ADDENDUM NO 1 (Rev 01/2017)

RE: **Daniels L&S SB Floor RISE Laser Lab Renovation
University of Wisconsin – Madison
Madison, Wisconsin
MSN Project No. 0047-2510 / UWSA Project No. A-25-008**

FROM: **Aro Eberle Architects
433 W. Washington Ave, Suite 400
Madison, WI 53703**

Graphic Scale	See Details
UWSA Number	A-25-008
MSN Number	0047-2510
Set Type	BD
Date Issued	06/09/2026
Sheet Number	F100A

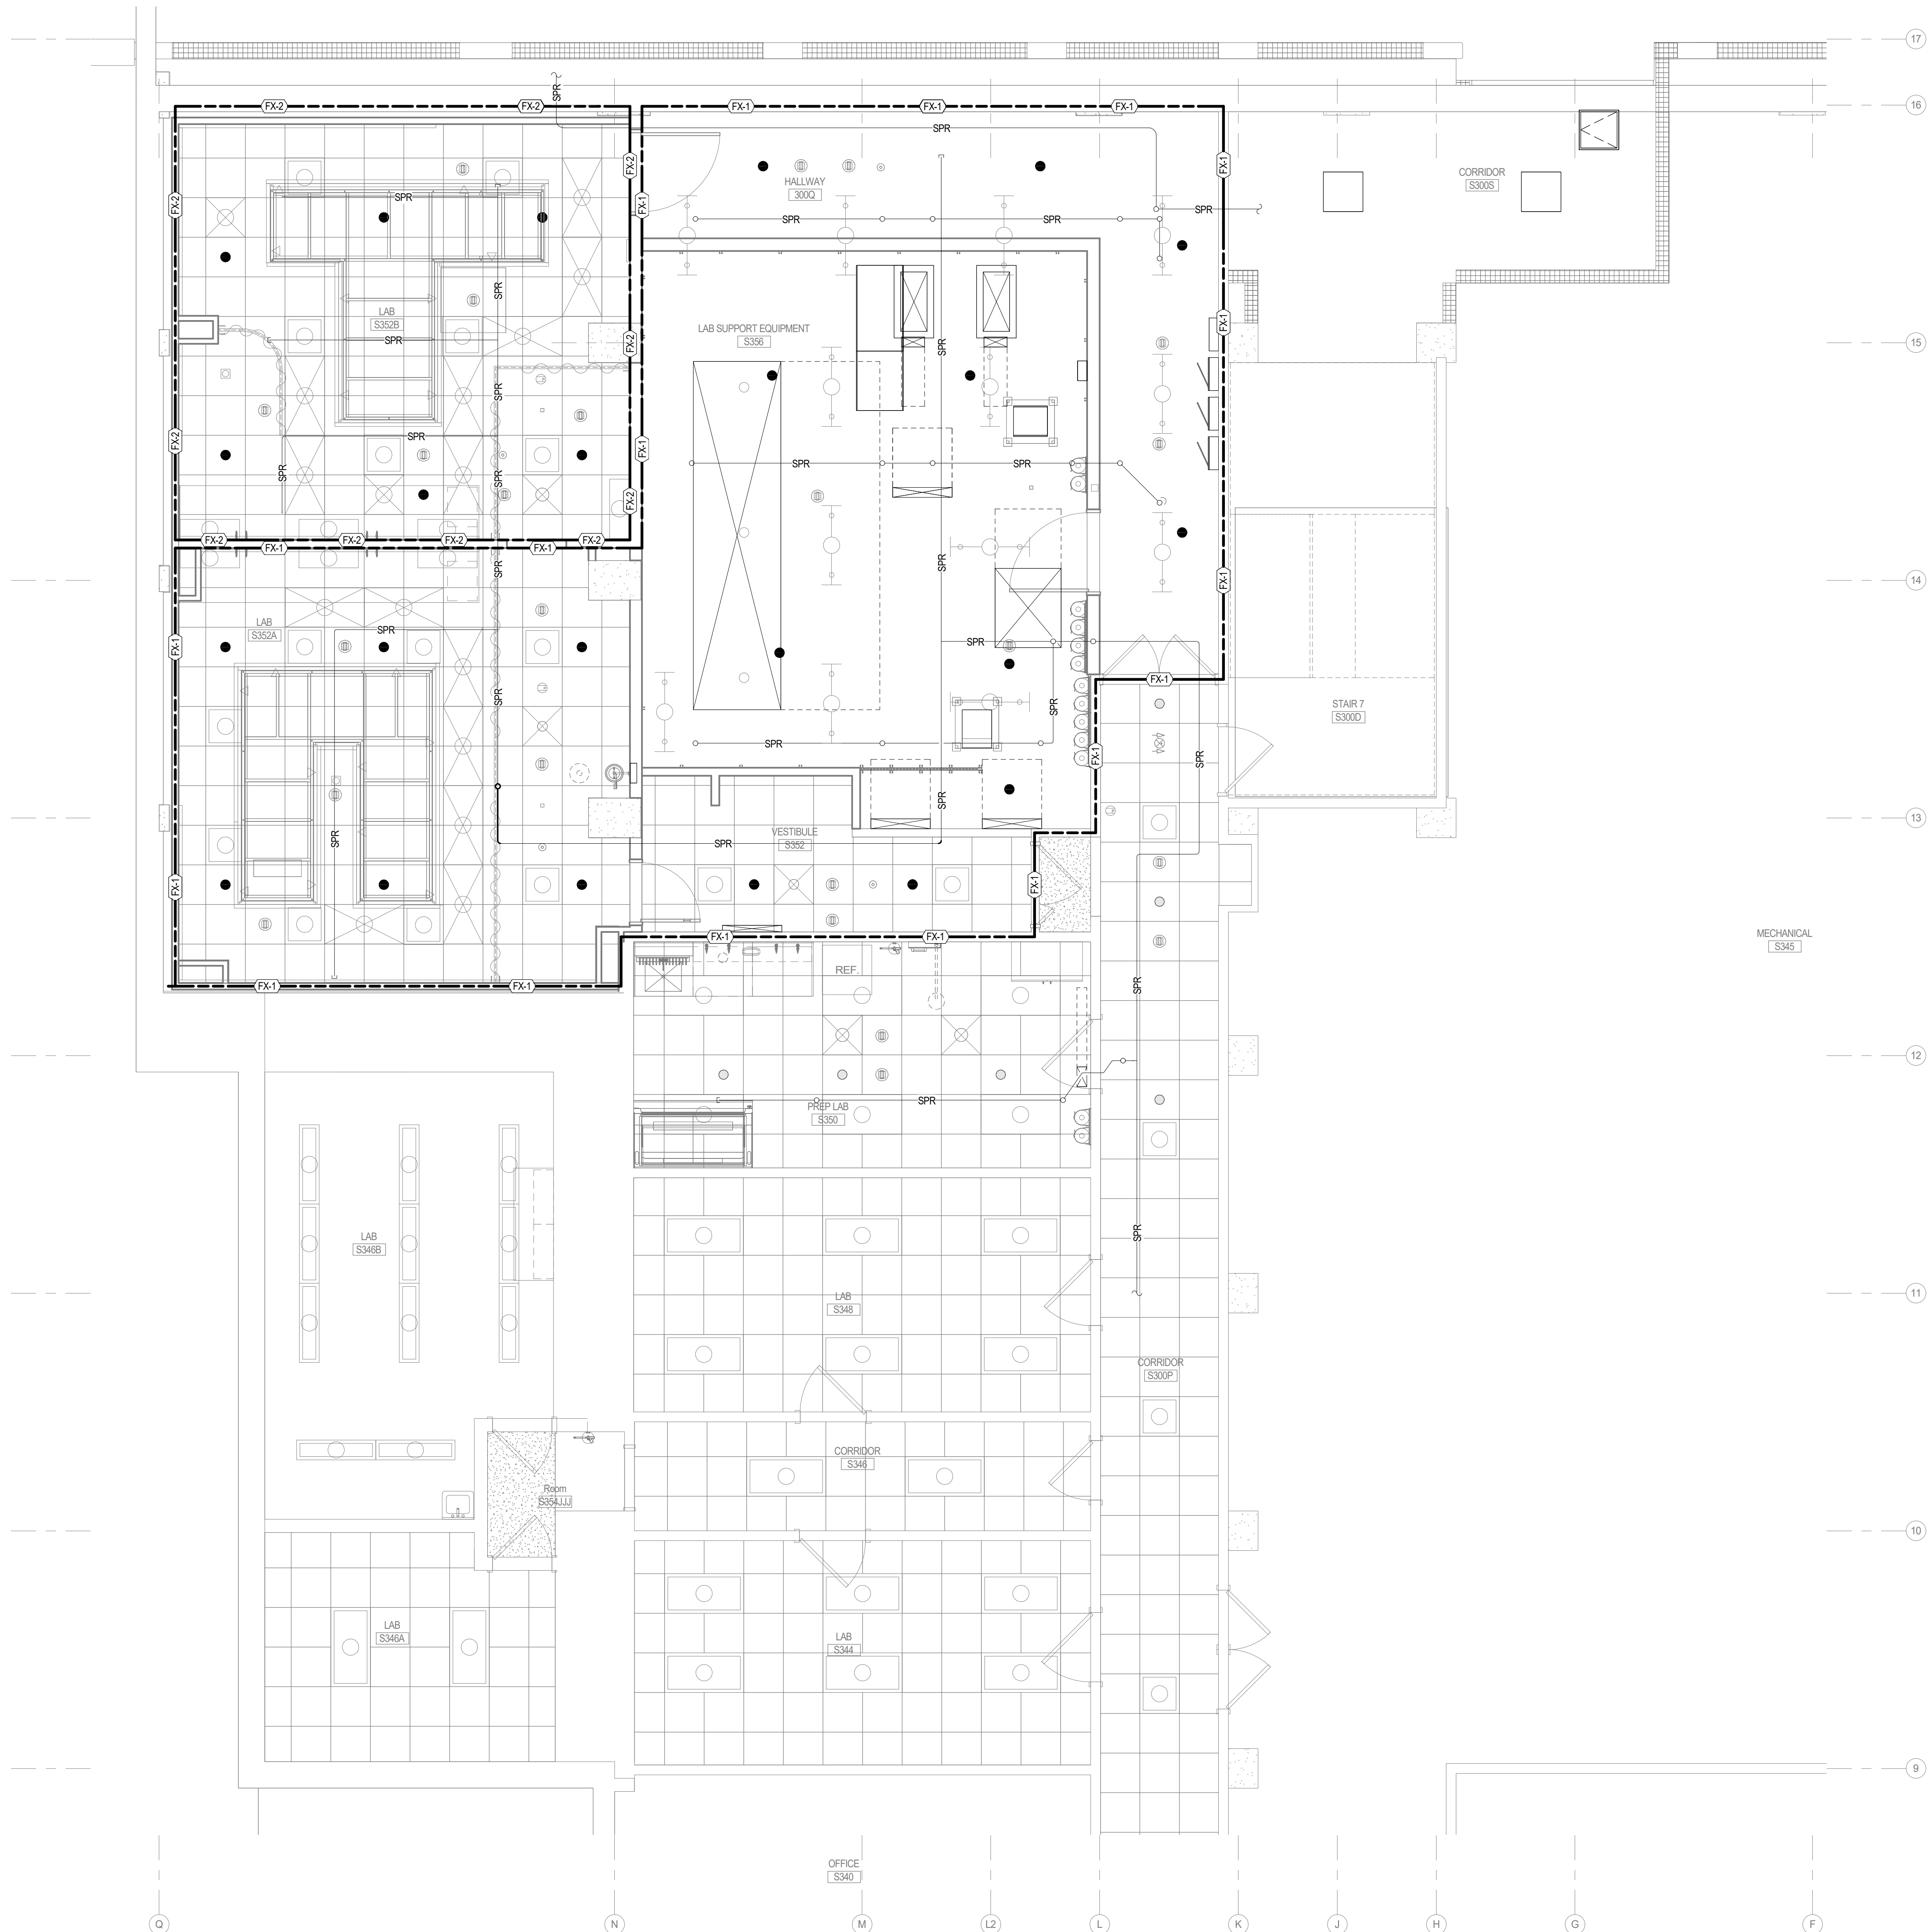
- 1 8. Sheet F100A – Sub-Basement Partial Fire Suppression Plan – Area A; Revise sheet as noted in this
2 Addendum.
 - 3 a. Revised Fire Suppression Keyed Note FX-2 to include pipe, pipe fittings and pipe supports to
4 be non-ferrous materials.
- 5
- 6 9. Sheet PD100A – Sub-Basement Partial Plumbing Demolition Plan – Area A; Revise sheet as noted in
7 this Addendum.
 - 8 a. Demolish a portion of 1/2”N and 1/2”A piping to allow for new isolation valves to be installed.
- 9
- 10 10. Sheet P100A – Sub-Basement Partial Plumbing Plan – Area A; Revise sheet as noted in this Addendum.
 - 11 a. Relocate isolation valve for 1/2”N piping. Relocate isolation valve for 1/2”A piping.
- 12
